Dolby Laboratories Inc

Field Bulletin 191

Models DA10 (all) and DA20 (below serial no. 502260) Cat. No. 611 Software Upgrade to Version 7.0 (Eprom Part No. 84060)

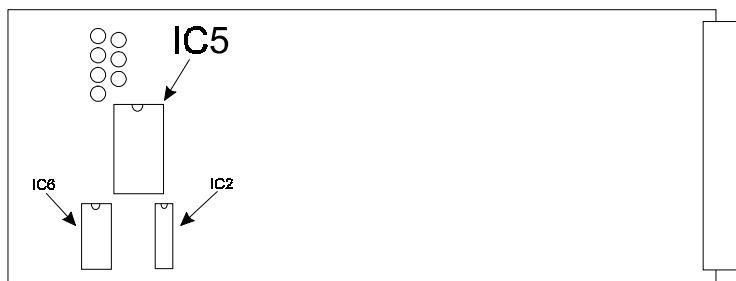
Model DA10 or Model DA20 may lose synchronization with a CP55 or CP65 Cinema Processor any time after format 10 has been selected, causing silence in the theater.

The symptom is silence in the theater, with the CP55 or CP65 indicating format 10, and the DA20 showing digital audio present. This symptom is most often seen when the film has had a large number of uncorrectable digital errors, but this is not necessary for the problem to appear.

After the power supply has been eliminated as the source of the problem, the Cat.No. 611 software should be upgraded to version 7.0.

1. EPROM part number **84060** contains the version 7.0 software. **The EPROM is extremely sensitive to static electricity. Be sure to remove any static on your hands by touching the chassis of the unit before handling the EPROM.**
2. Remove mains power to the DA10 or DA20
3. Carefully remove the Cat.No. 611 from the DA10 or DA20
4. Replace IC 5 with the new EPROM noting the correct orientation of the IC on the board.
